Our Ref:HAF-JBAU-00-00-RP-HM-0003-Flood_Risk_Letter.docx

25 November 2021

Haughead Farm: Updated Flood Risk Assessment

Figure 3 HEC-RAS long sections for the 0.5%AP (200 year) event on the Armour Burn, with and without climate change. Main culverts shown in grey.

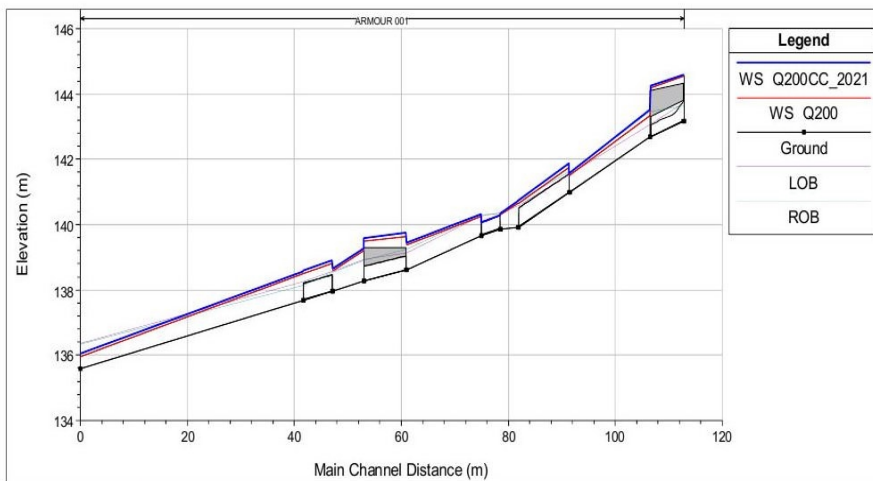
"A. The Finished Floor Levels of the Farmhouse and Steading must be at least 1m above ground level.

Reason: The FRA for the 2015 application recommended a FFL of 0.9m above ground level; climate change allowances for rainfall and river flow have increased since then to 35% (as per SEPA's 2019 guidance "Climate change allowances for flood risk assessment in land use planning") and we have to take these increases into account.

The HEC-RAS modelling suggests water depths of up to 0.29 m with velocities of greater than 1 m/s, for a 0.5% AP (200 year) event on the Armour Burn in the vicinity of the farm buildings. Following a 35% rainfall uplift to allow for climate change, flood depths in the vicinity of the site are expected to reach 0.36m. This is an increase of 0.03m compared to the depths associated with a 20% climate change uplift (0.33m).

Best practice states that Finished Floor Levels (FFLs) should be set to the 0.5% AP (200 year) plus climate change flood level plus an allowance for freeboard (usually 0.6m). Based on the newly modelled depths this would indicate an appropriate FFL of circa 0.96m (i.e. close to the 1 m requested by SBC) above surrounding ground level. From the supplied site plan, it is understood that the proposed finished floor level (FFL) of the steading is 140.90 mAOD and the existing ground level is circa 140.5 mAOD. The proposed steading FFL is therefore 0.4 m higher than the ground level. The FFLs of the northern and southern buildings making up the farmhouse are 139.90 mAOD and 141.23 mAOD respectively and the existing ground levels are 139.50 mAOD and 141 mAOD. The proposed FFLs of the steading and the northern portion of the farmhouse are therefore 0.4 m and 0.2 m higher than the neighbouring ground level, respectively. Additional raising of the FFLs would therefore be needed in order to meet SBC's requirements. Alternatively, 1D/2D modelling could be used to refine the flood estimates at the development locations and this could perhaps reduce the flood level estimated by more accurately simulating floodplain flow on the slope through the site.

Figure 4 0.5%AP (200 year) with and without climate change events on the Armour Burn at the C-road culvert.

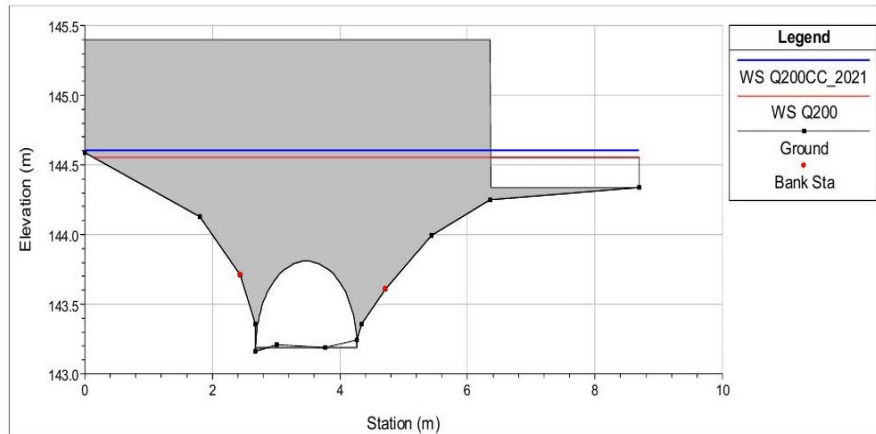
Reason: The culverts on the access road (B709 South Of Tweed Bridge To U83-1 At Haughhead) and within the site are under capacity and flow paths within the site need to be managed to reduce flood risk to the buildings on site.

bridge culvert is estimated to be about 1.5 m³/s. At the 0.5% AP (200 year) event, which has a flow of 3.7 m³/s, the modelling suggests that the C-road could be overtopped on the right bank with an estimated depth of 0.22 m (Figure 10). The pathway for the water would then be over the road and through the farm building site and associated buildings before heading towards the Tweed (Figure 5).

Figure 5 Pre-Development Flow Pathways

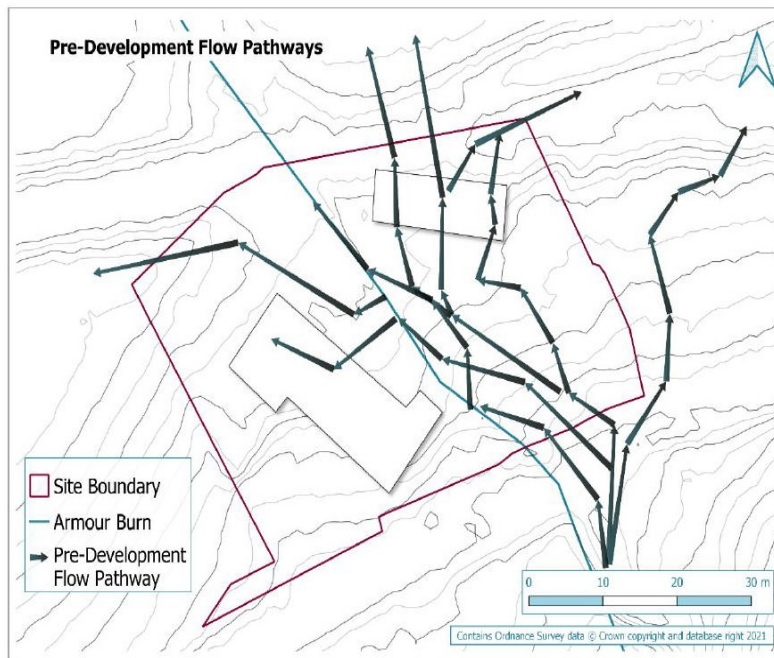
B. Post- development flow path drawings need to be submitted and show that the potential flood risk to the proposed buildings, associated with the flow paths, has been mitigated.

In the pre-development situation, the primary flood risk to the eastern building is expected to arise from flood waters flowing out of bank following overtopping of the C-road bridge. From here water is expected to follow the slope of the site, flow over the road and towards the eastern building. From here some water is expected to re-enter the armour burn whilst some is expected to inundate the building. Following flooding of the eastern building, flood waters are then expected to continue off the site and towards the River Tweed.

The western building is also at risk of flooding; however it is not expected to be at risk from overtopping of the C-road bridge. Instead flood risk to the western building will likely be due to out of bank flow between cross sections 0.0845 and 0.0778. It should be noted that flood depths on the left bank of the Armour Burn are only expected to be around 0.01m. Following out of bank flow in the middle of the site, water is expected to flow west and then south before ultimately travelling off site.
